No. AS365-52.00.29

ALERT SERVICE BULLETIN

DOORS - Emergency exit
Emergency evacuation labels for helicopters
installed with fixed parts of FLIR system

Corresponds to modification MC90B73

Figure 3

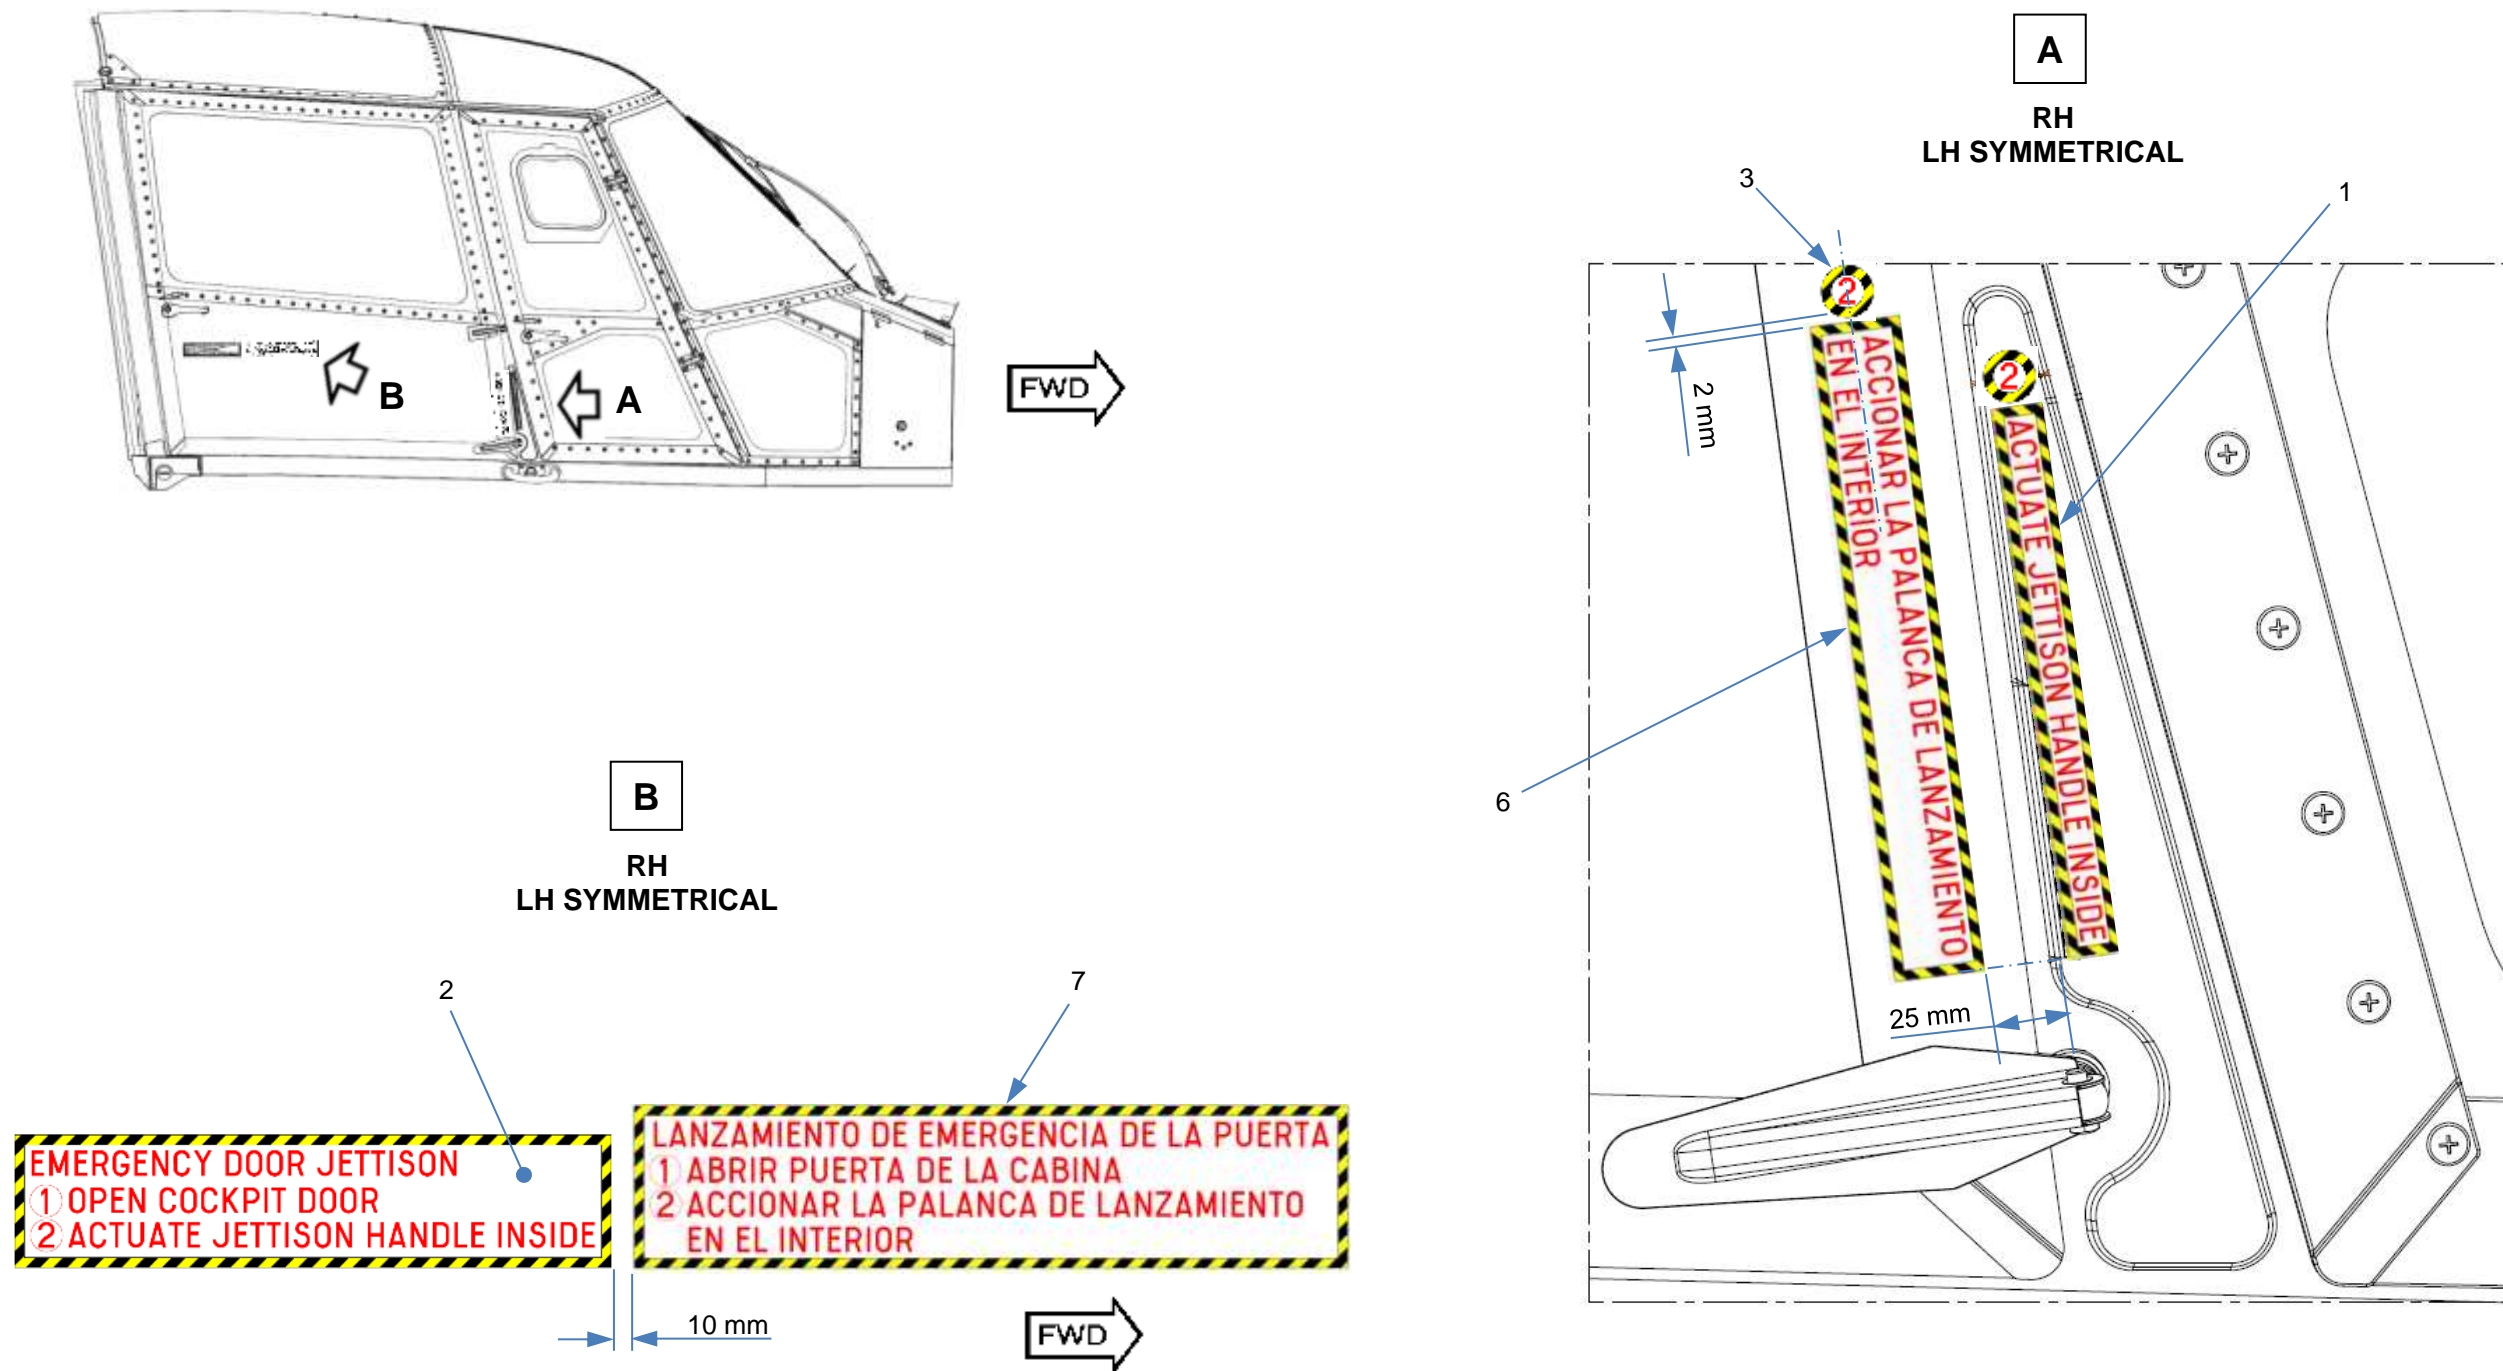
- If Japanese text is required:
 - . Install the label (4) adjacent to the label (1) ([Figure 2](#), DETAILS A and B).
 - . Install the label (5) adjacent to the label (2) ([Figure 2](#), DETAILS D and E).
 - . Install the label (3) above the label (4) ([Figure 2](#), DETAILS A and B).
- If Indonesian text is required:
 - . Install the label (8) adjacent to the label (1) ([Figure 2](#), DETAILS A and C).
 - . Install the label (9) adjacent to the label (2) ([Figure 2](#), DETAILS D and F).
 - . Install the label (3) above the label (8) ([Figure 2](#), DETAILS A and C).
- If Spanish text is required:
 - . Install the label (6) adjacent to the label (1) ([Figure 3](#), DETAIL A).
 - . Install the label (7) adjacent to the label (2) ([Figure 3](#), DETAIL B).
 - . Install the label (3) above the label (6) ([Figure 3](#), DETAIL A).
